SERVICE BULLETIN NO. 138

Placard Installation

AA1-0001 thru AA1-0459, AA1A-0001 thru AA1A-0470 and

AA1B-0001 thru AA1B-0177

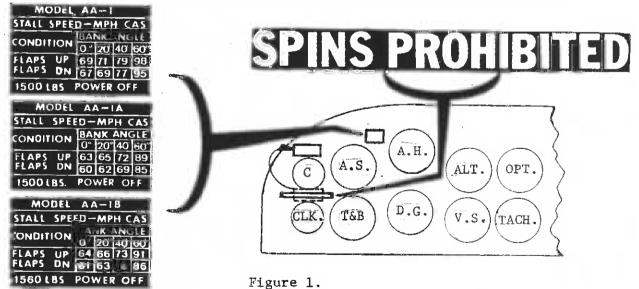
A "Stall Speed Vs Bank Angle" placard and a "Spins Prohibited" placard shall be installed on the instrument panel of the above listed aircraft. AA1B-0178 and on aircraft will have the placards installed at the factory. Appropriate placard part no. vs aircraft serial numbers are listed below:

Remove compass card from present position and reinstall above compass. Thoroughly clean the indicated areas of the instrument panel with isopropyl alcohol. the panel surface is thoroughly dry, remove the protective backing from the placards and firmly press them in place as shown in Figure 1. Make an entry in the Aircraft Log, that Service Bulletin No. 138 has been complied with.
